Access Compliance Report

Public Rights-of-Way

(Curb Ramps)

Intersection ID: 15725	Main Street: CLANTON_RD	Cross Street: S_TRYON_ST	Location: SE
ADA ID: 89CF86AF5EF1	Ramp Type: Perp	Initial Pass/Fail: Fail	Overall Compliance: No
Severity Score: 26.25			
Codes/Mitigation Info/Possible Solution		Field Measurements/Component Compliance

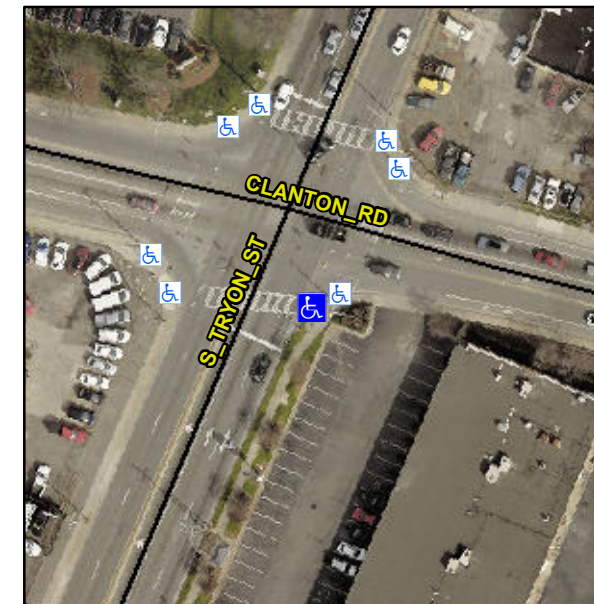
Not Found, R304.2.2, R304.5.3

Compliance	Description	Data	Compliance	Description	Data
N/A	Ramp Length (in)	60.0	No	Ramp Slope (%)	12.9
Yes	Ramp Width (in)	48.0	No	Ramp XSlope (%)	4.0
N/A	Flare Type LT	N/A	N/A	Flare Type RT	N/A
N/A	Flare Slope LT (%)	N/A	N/A	Flare Slope RT (%)	N/A
N/A	Flare Traversable LT?	N/A	N/A	Flare Traversable RT?	N/A
N/A	Landing Length (in)	N/A	N/A	DWS Provided?	N/A
N/A	Landing Width (in)	N/A	N/A	DWS Contrast?	N/A
N/A	Landing Slope (%)	N/A	N/A	DWS Length (in)	N/A
N/A	Landing X Slope (%)	N/A	N/A	DWS Full Width?	N/A
N/A	Landing Curb? (Y/N)	N/A	N/A	DWS Offset (in)	N/A
N/A	Shared Landing?	N/A			
N/A	Gutter Ponding?	N/A	N/A	Gutter Slope (%)	N/A
N/A	Gutter Lip Ht (in)	N/A	N/A	Gutter X Slope (%)	N/A
N/A	Painted X Walk1?	Yes	N/A	Painted X Walk2?	N/A
	X Walk 1 Direction	To W		X Walk 2 Direction	N/A
N/A	X Walk 1 Width (in)	102.0	N/A	X Walk 2 Width (in)	N/A
	X Walk 1 Slope (%)	2.3		X Walk 2 Slope (%)	N/A
	X Walk 1 X Slope (%)	1.1		X Walk 2 X Slope (%)	N/A

Remove & Replace Entire Ramp.
